Access Compliance Report

Public Rights-of-Way

Intersection ID: 44243	Main Street: KIEV_DR	Cross Street: VALERIE_DR	Location: SW
ADA ID: C9F87F11715B	Ramp Type: PerpDiag	Initial Pass/Fail: Fail	Overall Compliance: No
Severity Score: 8.75			
Codes/Mitigation Info/Possible Solution		Field Measurements/Component Compliance

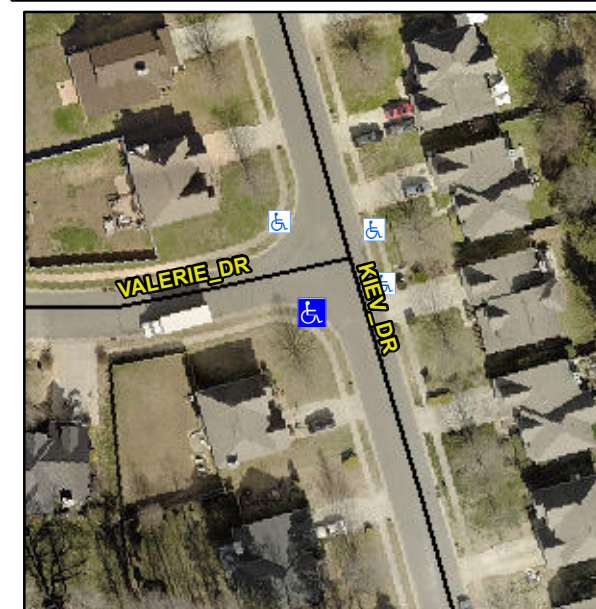
Not Found, R304.5.1

Compliance	Description	Data	Compliance	Description	Data
N/A	Ramp Length (in)	48.5	Yes	Ramp Slope (%)	6.9
No	Ramp Width (in)	41.0	Yes	Ramp XSlope (%)	0.8
N/A	Flare Type LT	N/A	N/A	Flare Type RT	N/A
N/A	Flare Slope LT (%)	N/A	N/A	Flare Slope RT (%)	N/A
N/A	Flare Traversable LT?	N/A	N/A	Flare Traversable RT?	N/A
N/A	Landing Length (in)	N/A	N/A	DWS Provided?	N/A
N/A	Landing Width (in)	N/A	N/A	DWS Contrast?	N/A
N/A	Landing Slope (%)	N/A	N/A	DWS Length (in)	N/A
N/A	Landing X Slope (%)	N/A	N/A	DWS Full Width?	N/A
N/A	Landing Curb? (Y/N)	N/A	N/A	DWS Offset (in)	N/A
N/A	Shared Landing?	N/A			
N/A	Gutter Ponding?	N/A	N/A	Gutter Slope (%)	N/A
N/A	Gutter Lip Ht (in)	N/A	N/A	Gutter X Slope (%)	N/A
N/A	Painted X Walk1?	No	N/A	Painted X Walk2?	No
	X Walk 1 Direction	To E		X Walk 2 Direction	To N
N/A	X Walk 1 Width (in)	N/A	N/A	X Walk 2 Width (in)	N/A
	X Walk 1 Slope (%)	1.3		X Walk 2 Slope (%)	1.3
	X Walk 1 X Slope (%)	1.0		X Walk 2 X Slope (%)	0.5

Remove & Replace Curb Ramp With Two New Directional Ramps or Equivalent.
